TECHNICAL SERVICE BULLETIN
SB-71 2022-2024 Allegro Bay Motorhomes, Securing Front Cap

Technical Service Bulletin SB-71 Repair Instructions

Models Involved: 2022 – 2024 Allegro Bay motorhomes, all floorplans built between December of 2021 and July of 2023.

Purpose: Adding additional fasteners to secure the front cabover to the chassis and to change the sealant on the front cap to provide a better seal.

Figure 6

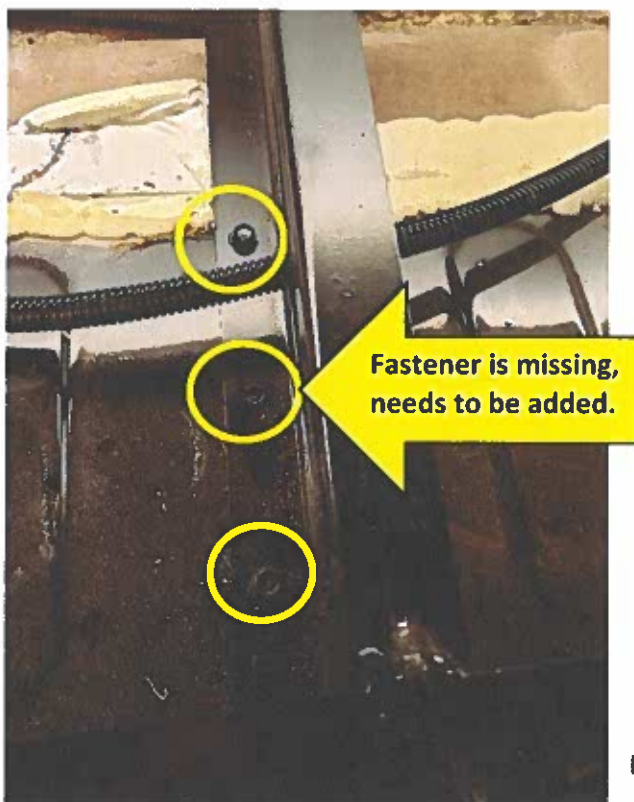
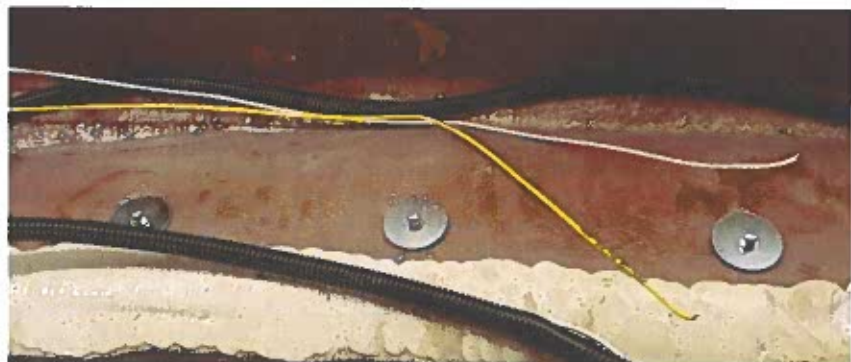
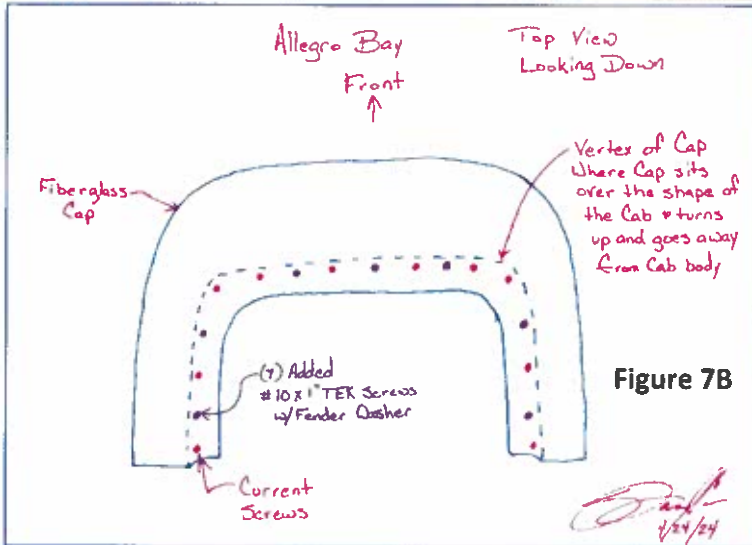
9. Inspect all holes in cab frame for screws being installed, Figure 6. Holes with no contact between the top of the cab and the frame do not need to have screws. If any holes in contact with the top of the cab are missing screws, install #10x1" TEK screws as needed.
